Addendum 1: Modeling Approach Description Appendix A2

MID-VALLEY DRAINAGE MANAGEMENT PLAN

ADDENDUM 1: July 17, 2012

SEC PROJECT NO. 110112

PROPOSED FACILITY
F14
FIGURE A

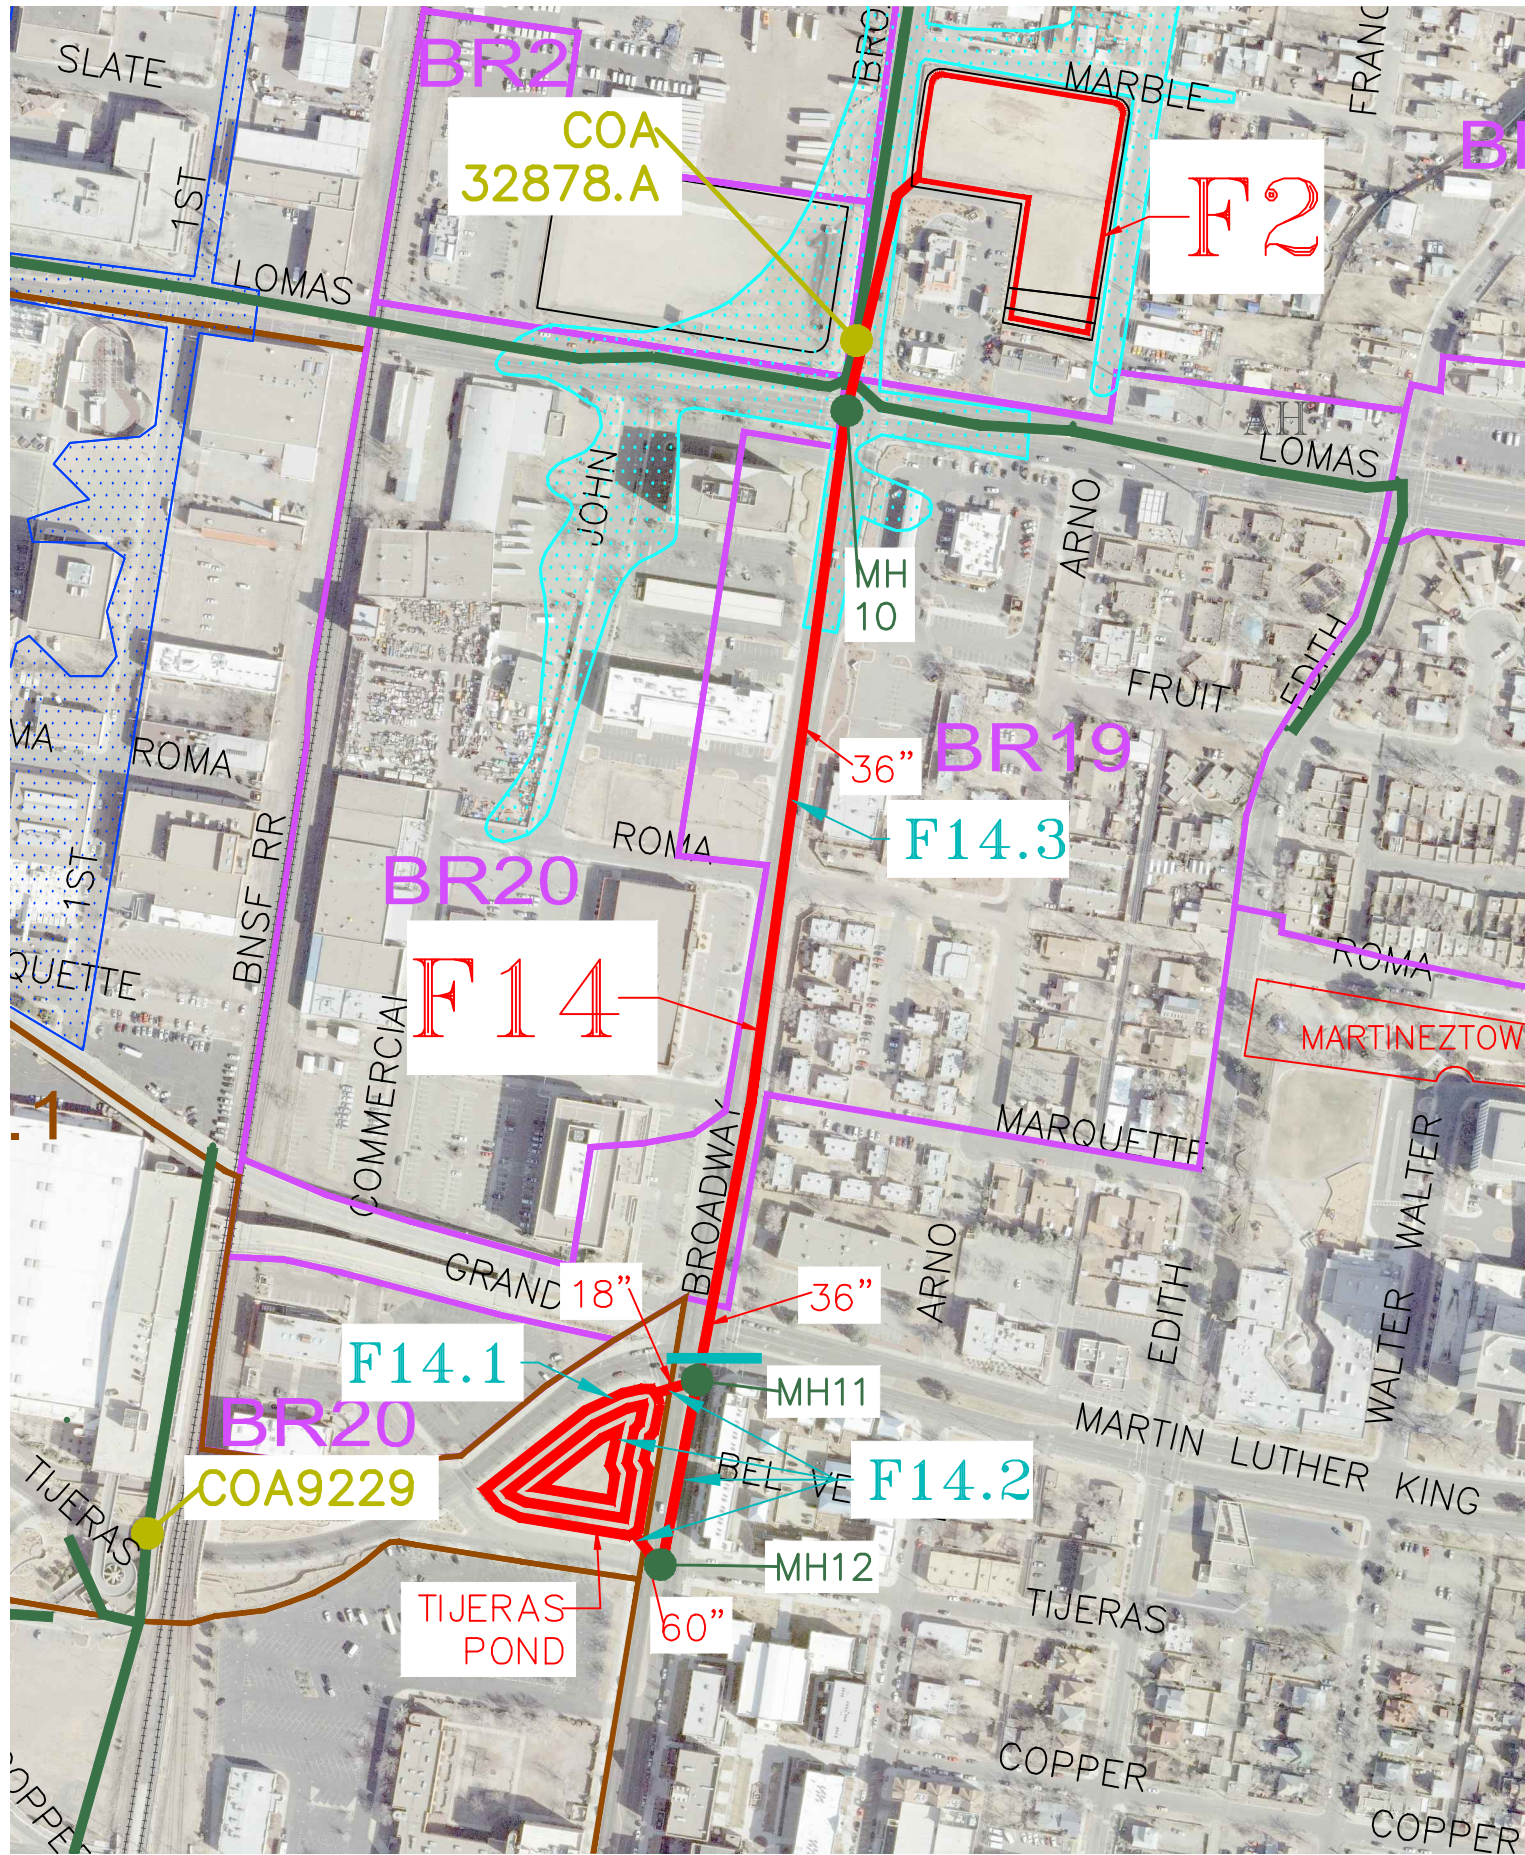
The original proposed Marble-Arno Pond failed upon the inclusion of the North Flow Hydrograph. Therefore the following changes were developed to create the current the Proposed Option 51 Model:

A proposed 36-in. storm drain was modeled from the intersection of Broadway-Tijeras to the intersection of Broadway-Lomas along with three additional manholes. The adjusted street surface area was computed based on a length of 1050 feet from the Broadway-Central to Broadway-Martin Luther King intersection based on methods specified in the original report Section 5 Table SP. The computations are included in **Table SP-A1, Appendix A2**. This street surface area was distributed equally to the three proposed manholes. The storm drain was modeled to outfall directly into the proposed Marble-Arno Pond.

At the beginning of the 36-in. storm drain, a 60-in. storm drain was modeled to drain directly to a proposed detention pond called the Tijeras Pond that was simulated at the northwest corner of Tijeras and Broadway. The purpose of the 60-in. storm drain and the Tijeras Pond was to divert and detain the North Flow Hydrograph. **See Figure 6-1.**

The pond was simulated to have a maximum depth of 14 feet with 1V:1H side slopes with a design storage volume of 7.68 ac-ft.

This pond was simulated to outfall with an 18-in. storm drain that joins into the 36-in. trunk line. The 36-in. storm drain continues north in Broadway and outfalls directly into the proposed Marble-Arno Pond.

North Flow 1 was added at MH12 at the very beginning of the storm drain at Broadway-Tijeras while North Flow 2 was added at MH 11, just south of Broadway-Martin Luther King. See **Figure A**.

- The boundary of the pond was extended south along Arno to include the two smaller lots
- The top of the pond was offset 10 ft. from the right of way for accessibility
- Side slopes were maintained at 1V:1H for a total storage volume of 17.55 ac-ft.
- Maximum depth of the pond is 12 feet

See **Figure A** for modified pond layout.

The proposed Tijeras Pond and associated storm drain eliminated the flooding described for existing conditions. The manhole flooding results are summarized in **Table A1.4**.

The proposed Marble –Arno Pond has 2.3 feet of freeboard and the Tijeras Pond has 1.1 feet of freeboard. The pond routing results are summarized in **Table A1.5**. There was minor flooding at the proposed manhole MH 11, which would be at the Broadway-Martin Luther King intersection, however the depth was 0.02 feet.
